ADDENDUM NO: 04

PROJECT: BCSC Columbus East High School – C4 Addition

PROJECT NO: 2025022

DATE: 11/14/2025

DRAWING TITLE:
GRADING PLAN

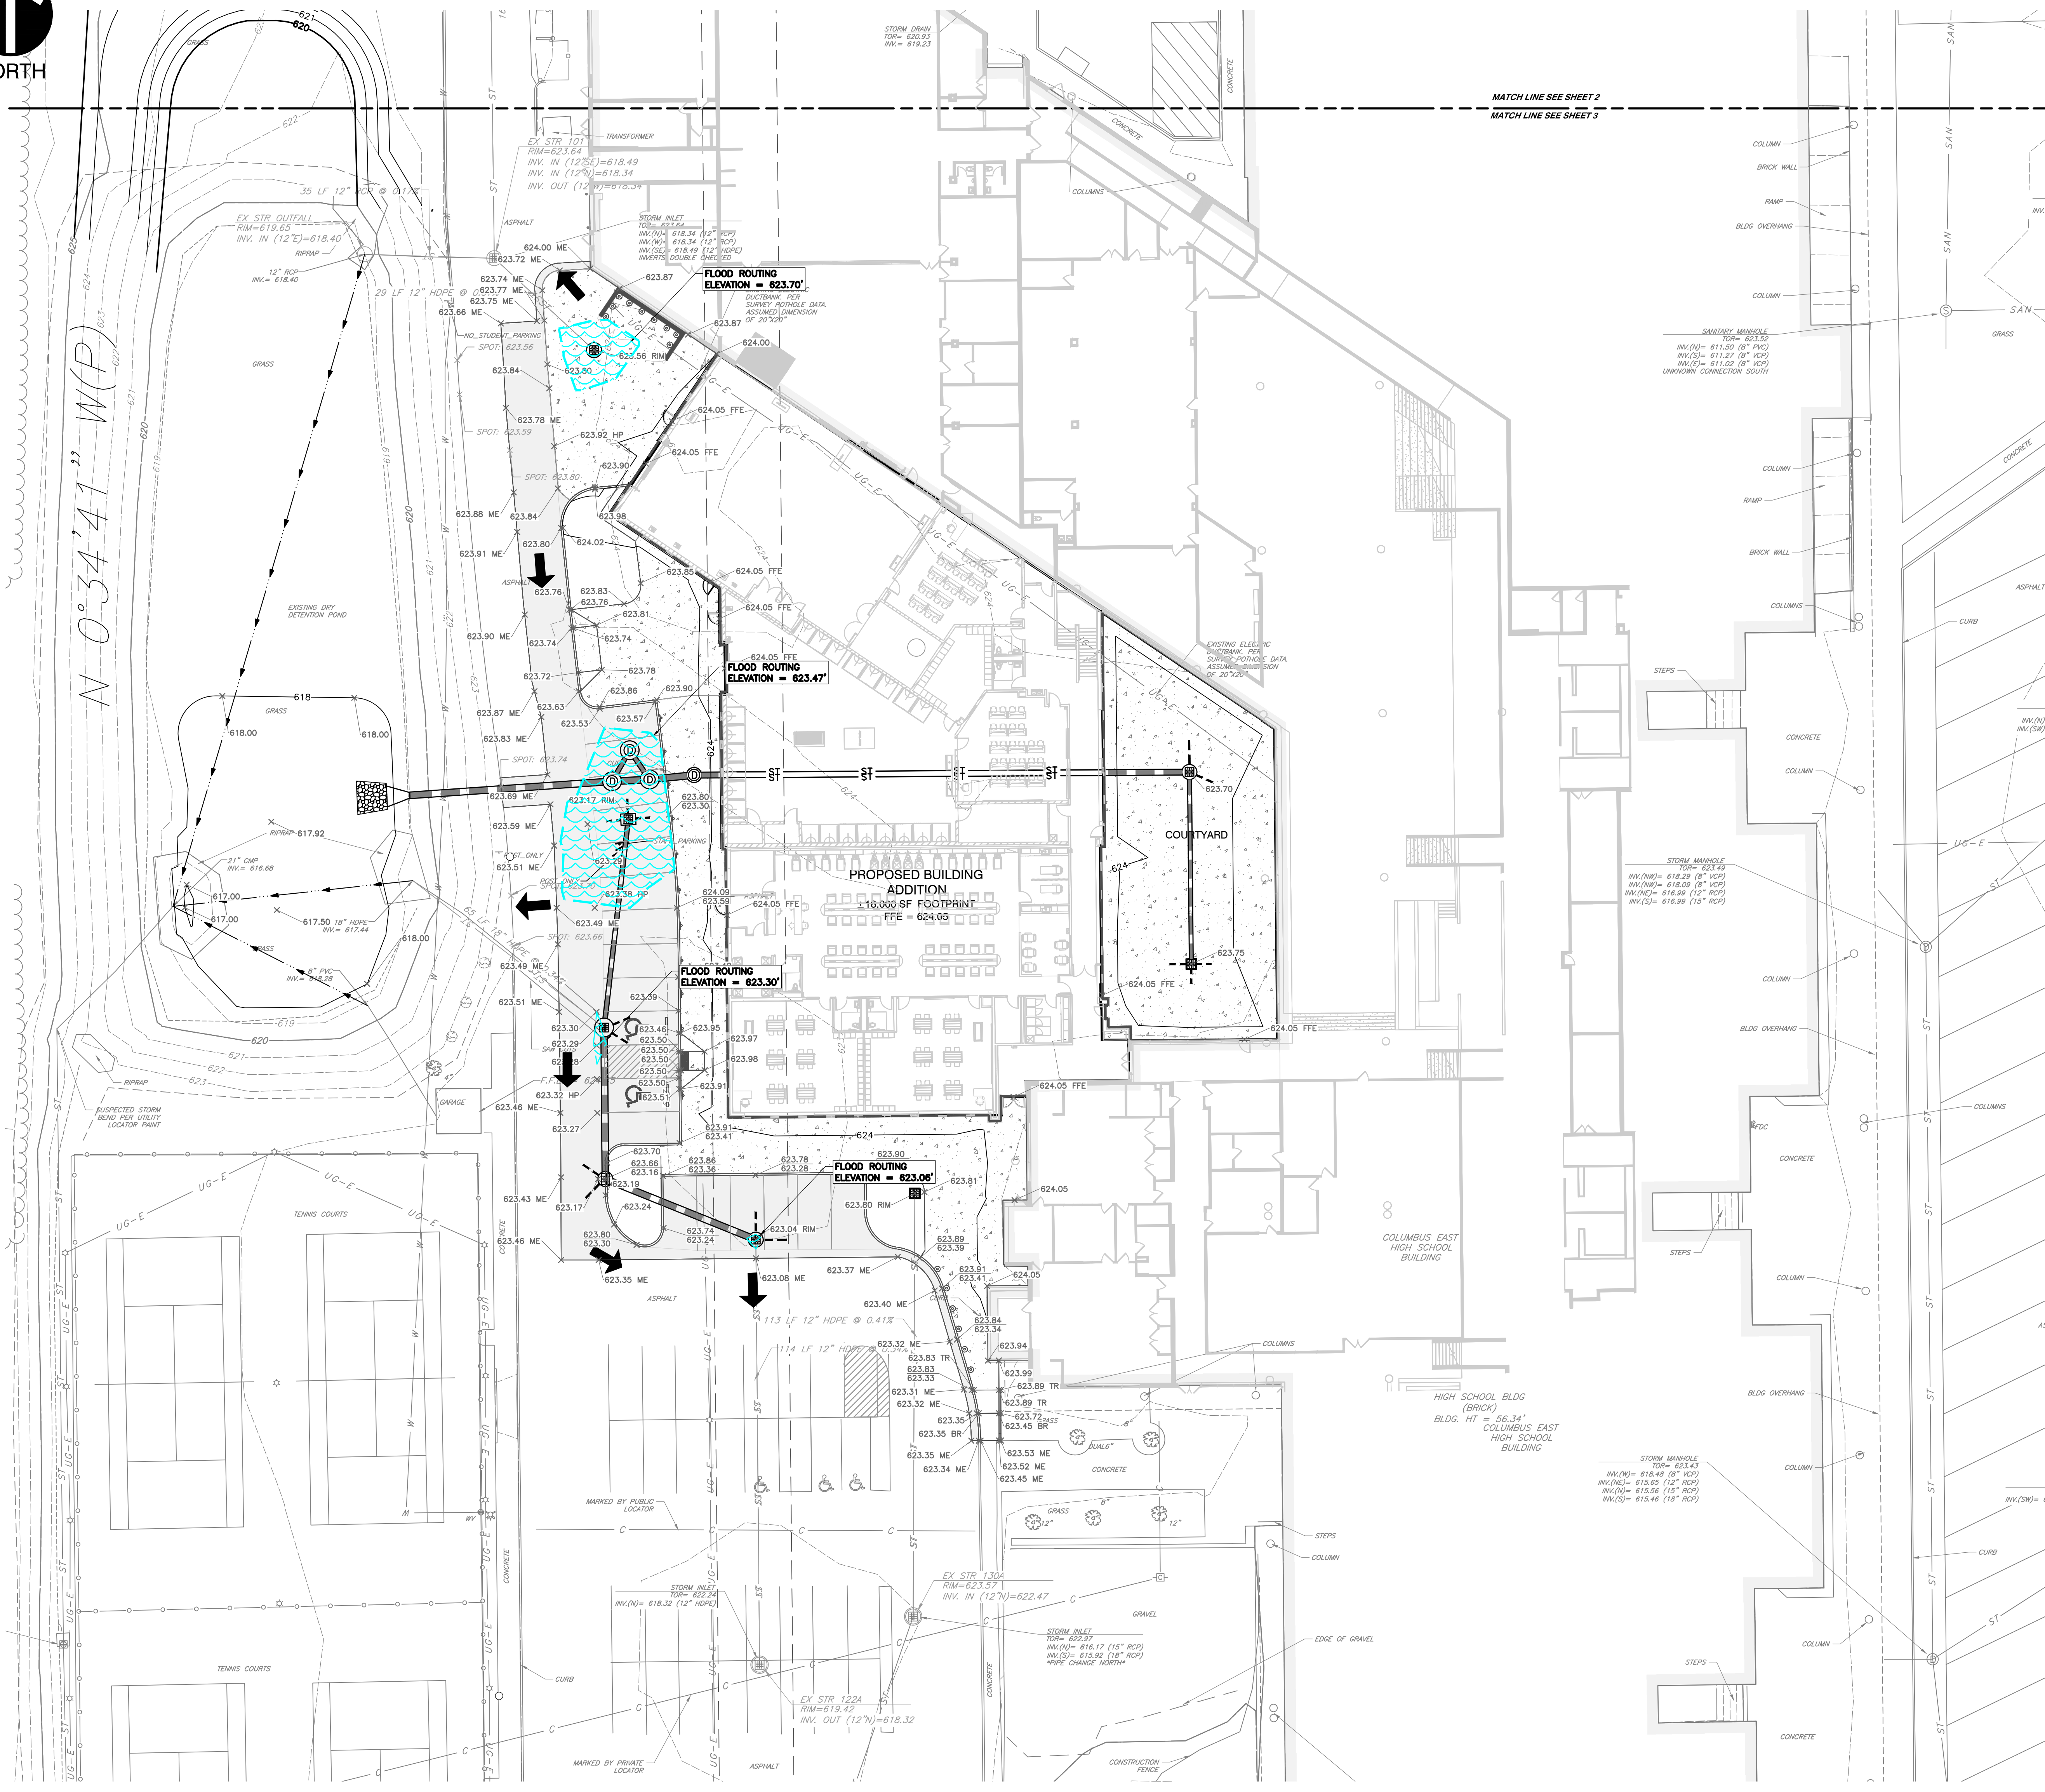
- A. Added spot shots to clarify pond modifications.

DRAWING TITLE:
EMERGENCY
FLOOD
ROUTING

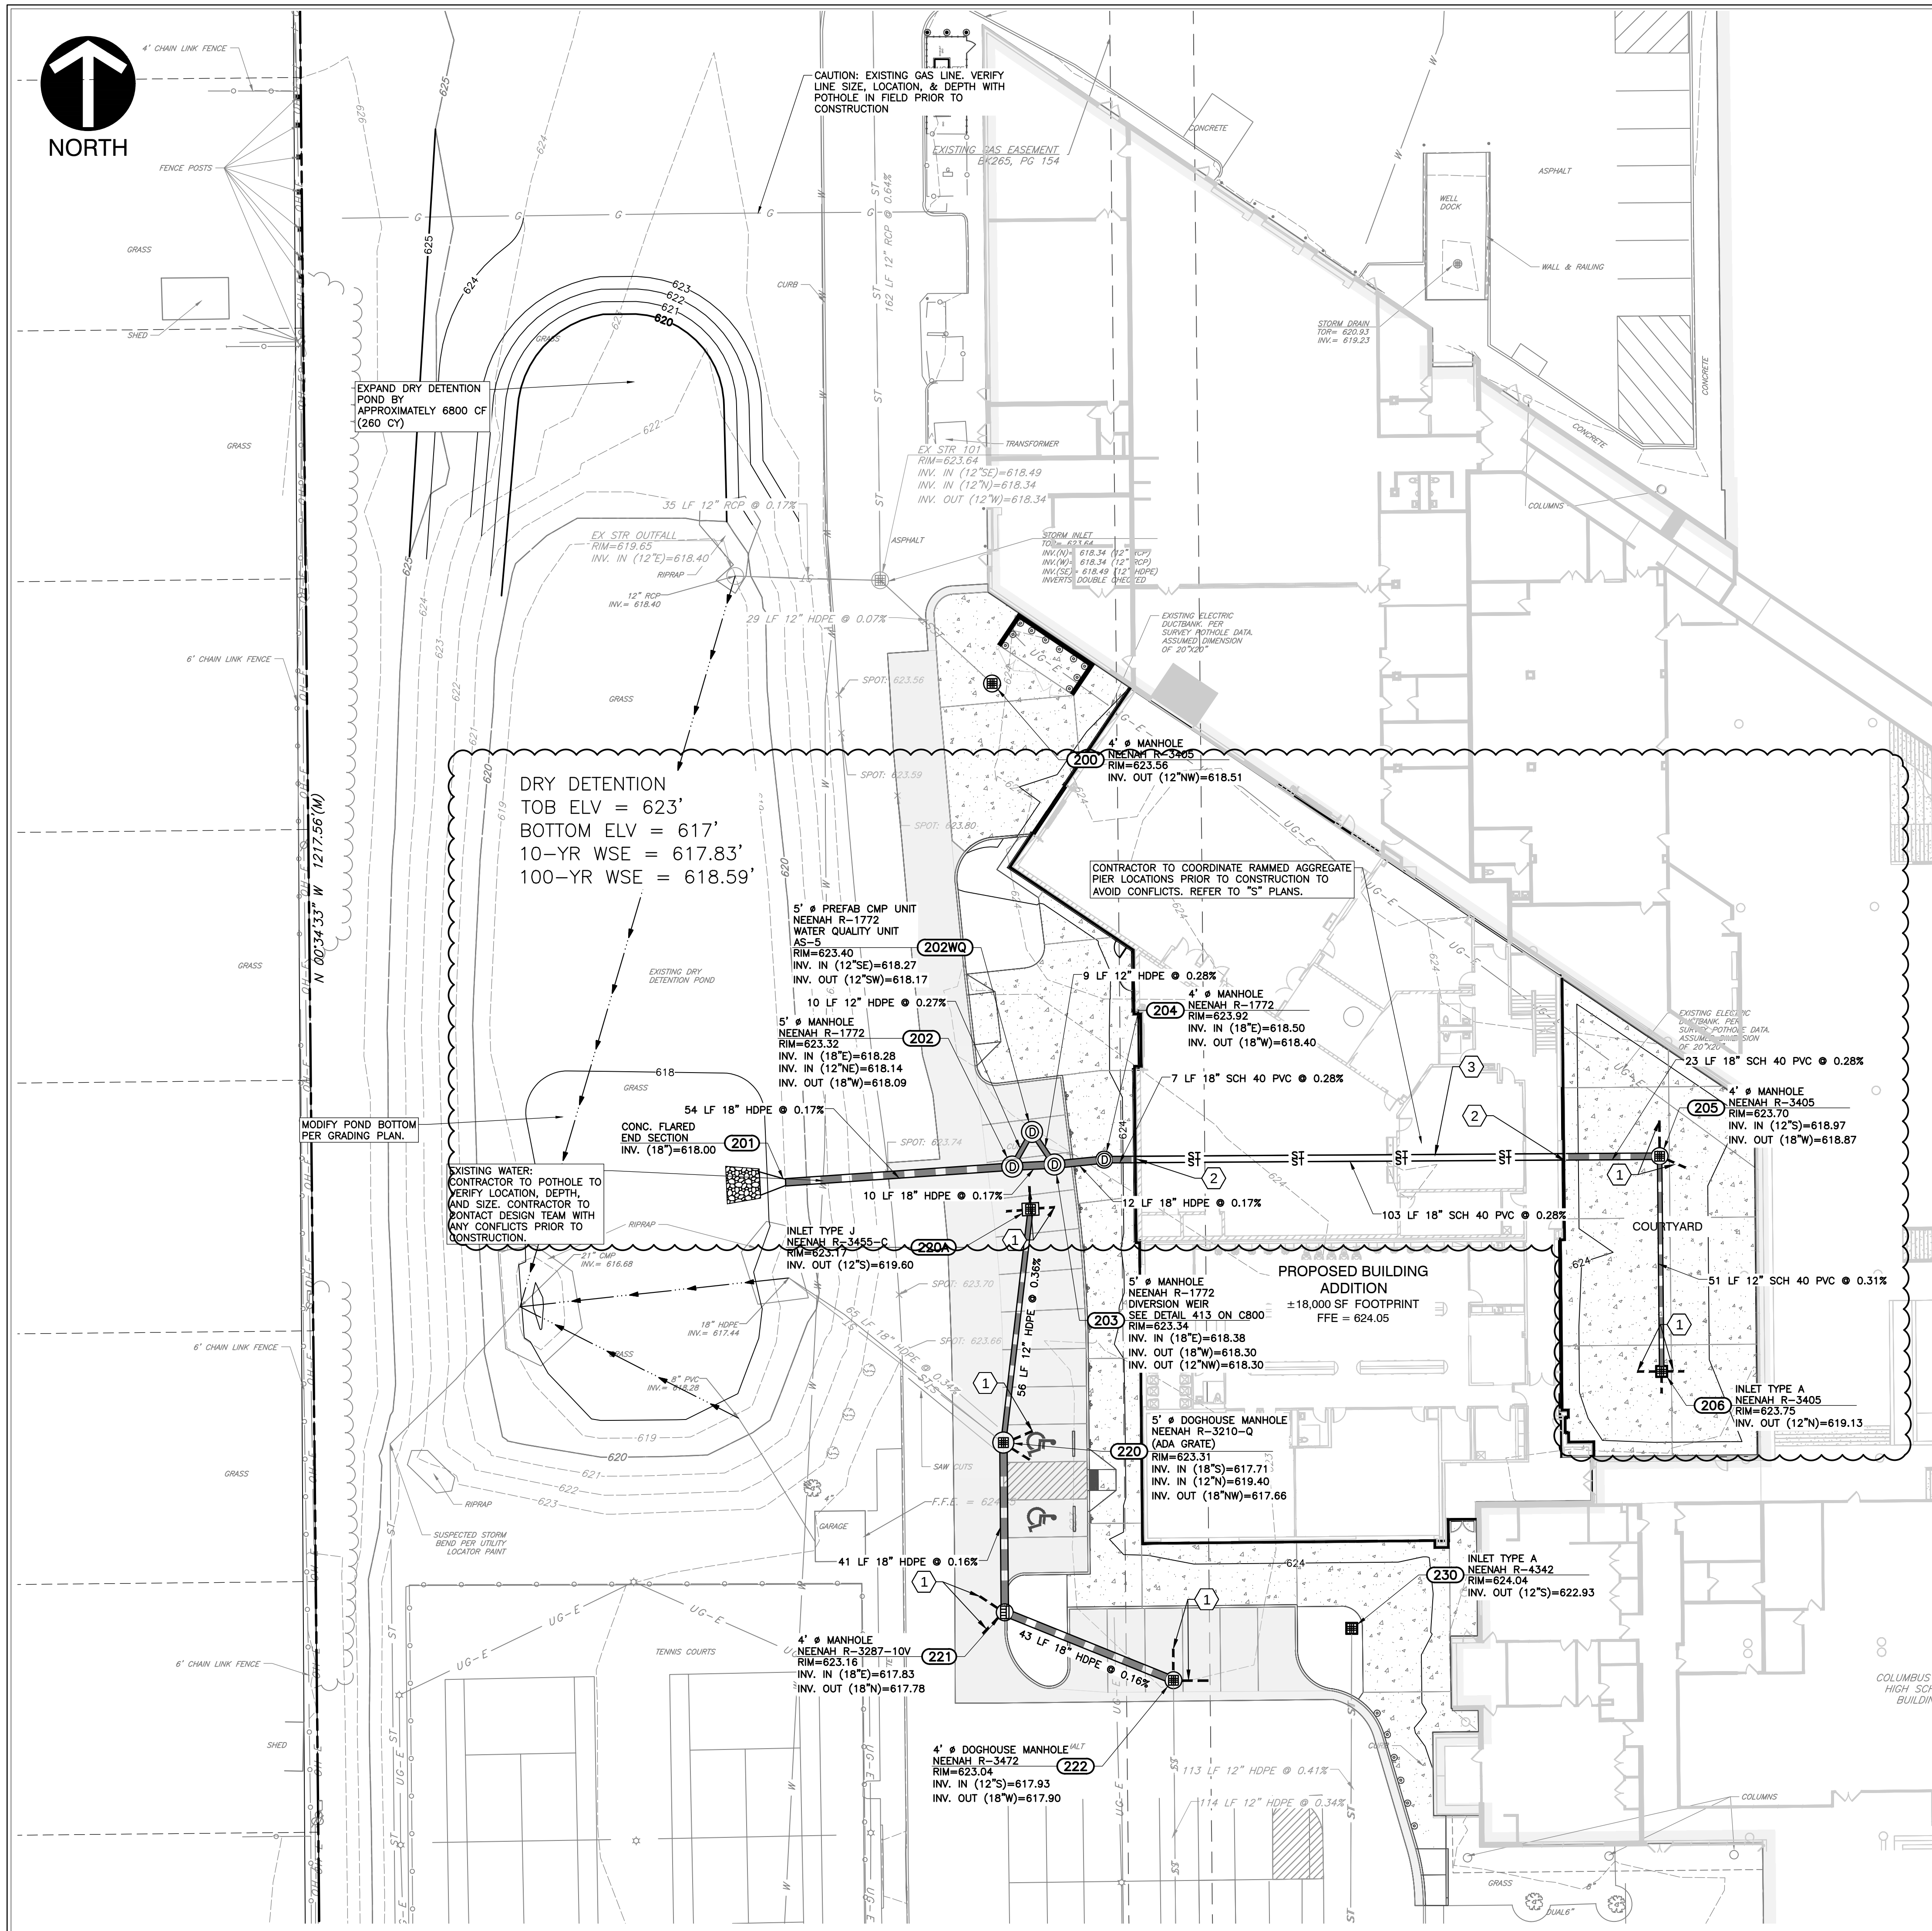
- A. Adjusted drawing's scale

DRAINAGE PLAN

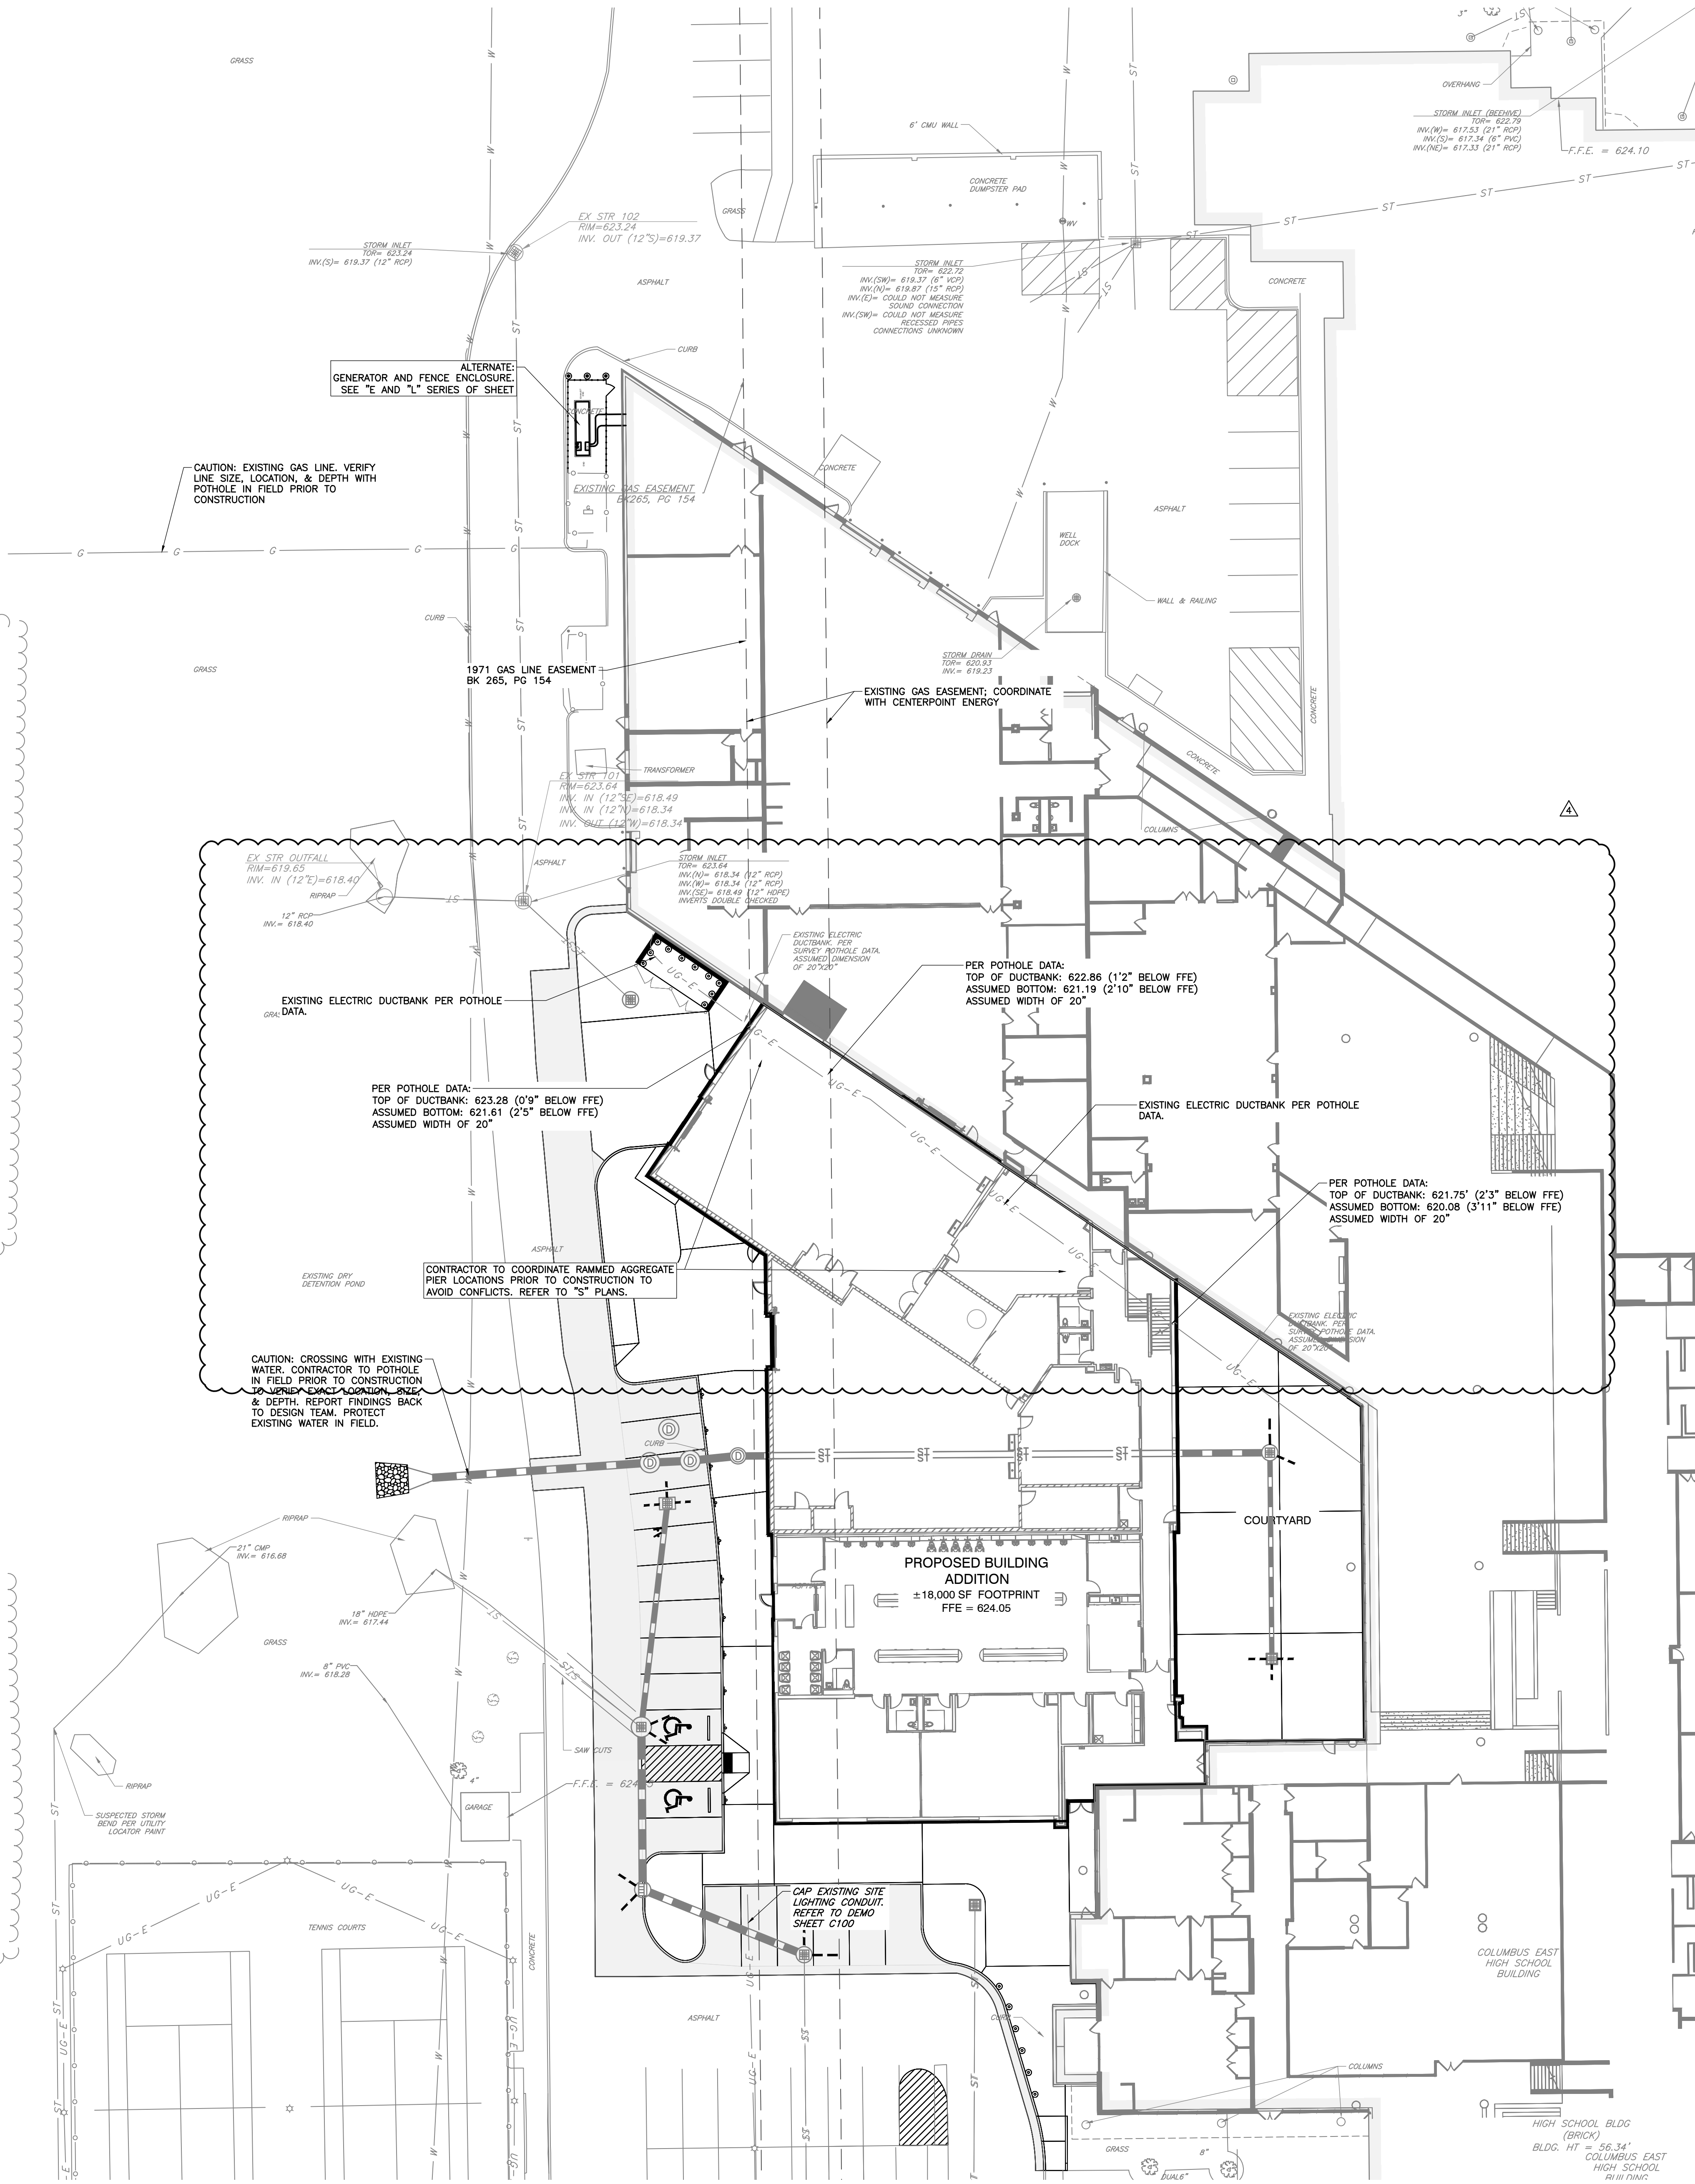
- A. Added language to specify the modifications to the existing dry pond. Specifically, a Bottom elevation to the Dry detention note.
- B. Added Keynote #3 to reference the plumbing plans for the proposed pipe under the building.
- C. Added a callout to draw attention to the required coordination with the rammed aggregate piers.
- D. Modified the pipe type for Pipe 206.
- E. Modified pipe 205.

5.1 C400-Storm pipe shown under the new addition calls for 15" Sch40 pvc. Is this a standard pipe size? Also, what type of pvc pipe is required in the courtyard? It is noted as 12" pvc. Is SDR35 acceptable? Or HDPE? Please advise.

A. No, do not use 15" Sch40 PVC. Refer to the updated C400 sheet. Utilize an 18" Sch40 PVC pipe under the building addition. Use a 12" Sch40 PVC pipe for the courtyard, as shown in the updated C400 sheet.
